00 91 03 ADDENDUM NUMBER 03

Project: W Lucas Rd Reconstruction and Widening

Project No.: 045-026

Addendum Date: June 12, 2026

STANDARD DRAWING NO. 3020

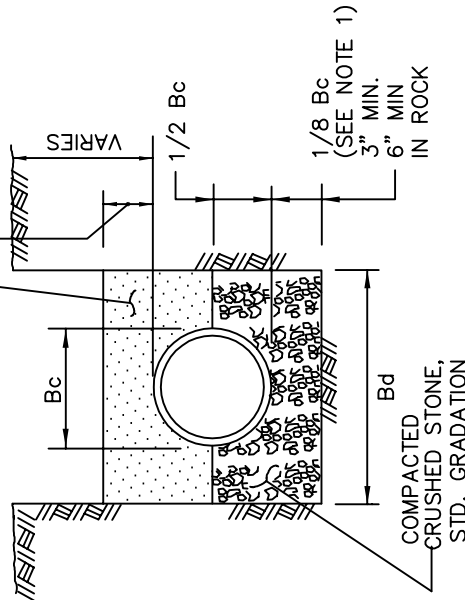
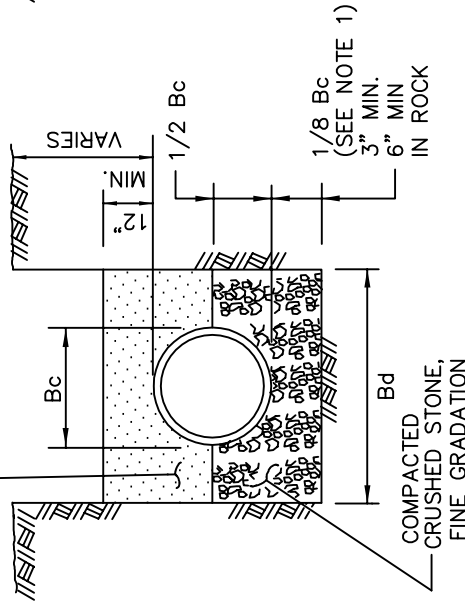
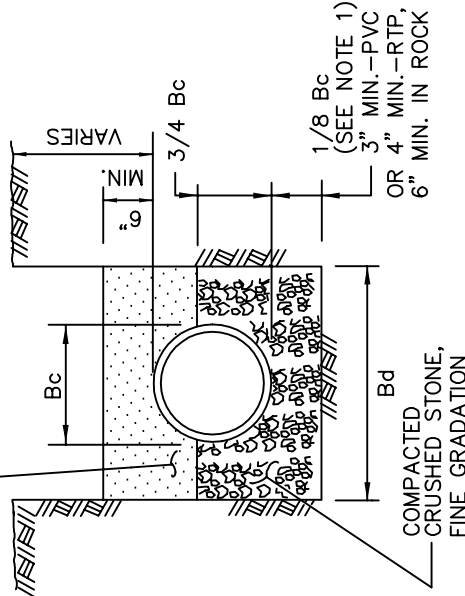
- 3.01 Appendix A – NCTCOG Embedment Class B+ Detail (3020)
- 3.02 Appendix B – W Lucas Rd Widening KMZ (For information Only)
- 3.03 Appendix C – Questions received via email prior to CivCast Q/A

5/26/2026	Will the bid date be pushed back as new bid form is still not available till 05/26/2026.	A revised bid date is included in addendum
5/22/2026	Can you please unlock the PDF so that we can extract sheets?	An unofficial set of plans marked "for review only and not for construction" without any seal or signature has been included in addendum
5/22/2026	Can you please enable the Q/A feature on Civcast so that we can submit questions through the website as requested?	Q&A has been changed to CivCast by addendum
5/21/2026	Please provide the applicable earthwork/excavation bid items for this project, along with the corresponding quantities.	Bid form has been updated per addendum.
5/21/2026	Could the embedment details for both the RCP and RCB installations be provided for this project? Please include the required bedding, embedment material, trench/backfill requirements.	Embedment details have provided per addendum.
